**Awareness of the Proximity of Vulnerable Road Users:
UN Regulation No. 158 (Reversing Motion)**

Proposal for Supplement 3 to the Original Version of UN Regulation No. 158 (Reversing Motion)

Submitted by the expert from the Republic of Korea*

Figure 1

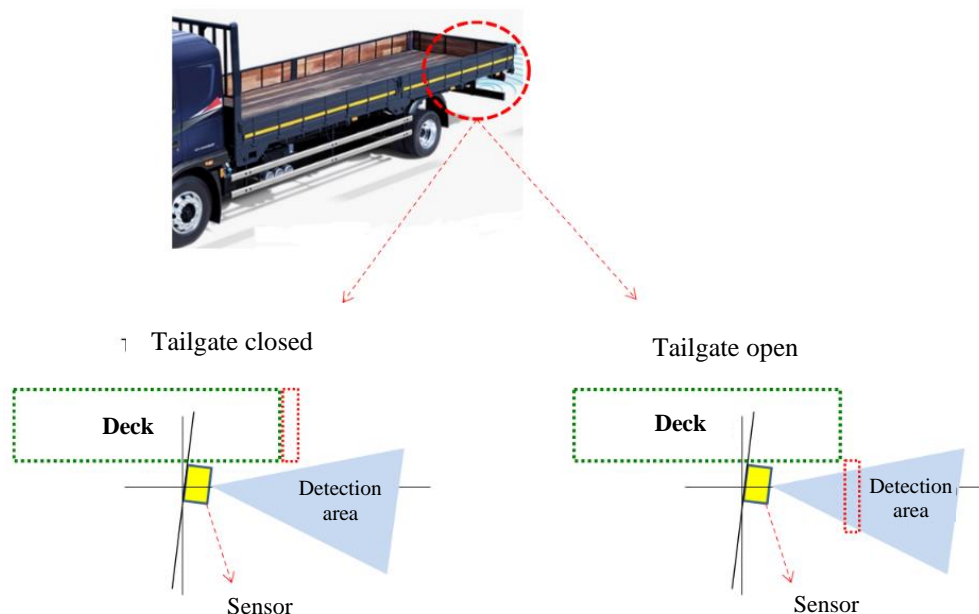
2. In addition, the test conditions should specify that not only rear hatches or trunk lids but also the tail gates of cargo trucks and van-type vehicles should be closed or latched in the normal conditions of vehicle operation during the test. For additional information on this matter, please refer to the following figures.

"1.3.3.4. Rear hatch ~~and~~, trunk lids: **and tail gates**.

If the vehicle is equipped with rear hatches, ~~or~~ trunk lids, **or tail gates**, they are closed and latched in their normal vehicle operating condition."
